Service Bulletin

Bulletin No.: 18-NA-063

Subject: Multiple Electrical Issues, Dead Battery, Start/Stop Inoperative, Instrument Cluster and Switch Backlighting Remain Illuminated, Battery Draw

Brand:	Model:	Model Year:		VIN:		Engine:	Transmission:
		from	to	from	to		
Cadillac	XT5	2017	2017			All	All
GMC	Acadia (VIN N)						
	Acadia	2018	2019				
Holden	Acadia	2019	2019

4977978

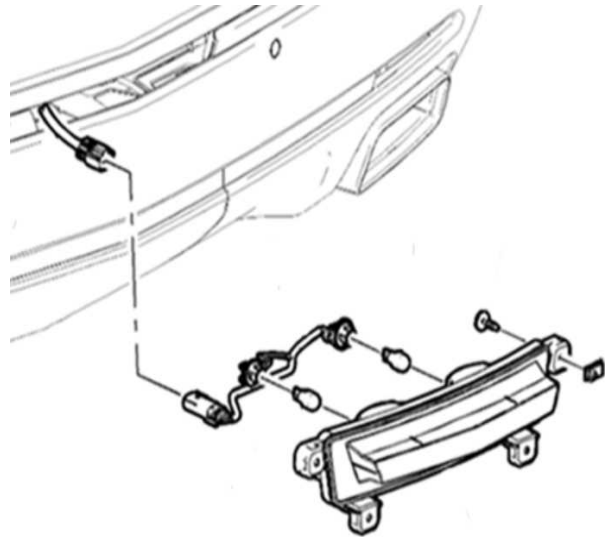
On vehicles that exhibit the above conditions or other electrical abnormalities, check the bulbs in the back up lamp locations.

- If the bulbs are found to be LED (1), the incorrect bulbs have been used and they need to be replaced with Incandescent bulbs.
- If the bulbs are found to be the proper incandescent bulbs (2), refer to SI for further diagnostic recommendations.

For backup bulb replacement, refer to the appropriate *Backup Bulb Replacement* procedure below.

4977982

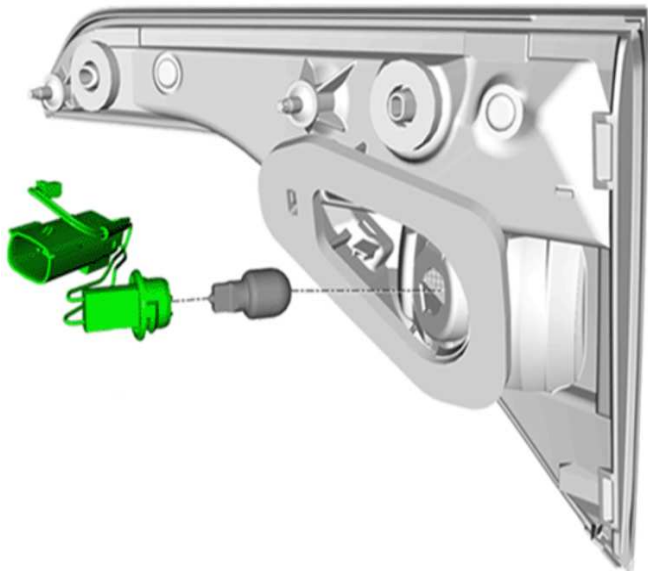
For Cadillac XT5 Models

1. Locate the backup lamp assembly underneath the rear fascia.
2. Remove the bulb from the lamp assembly by turning it counterclockwise and pulling straight out.
3. Remove the bulb and replace.
4. Reverse Steps 2 and 3 for assembly.
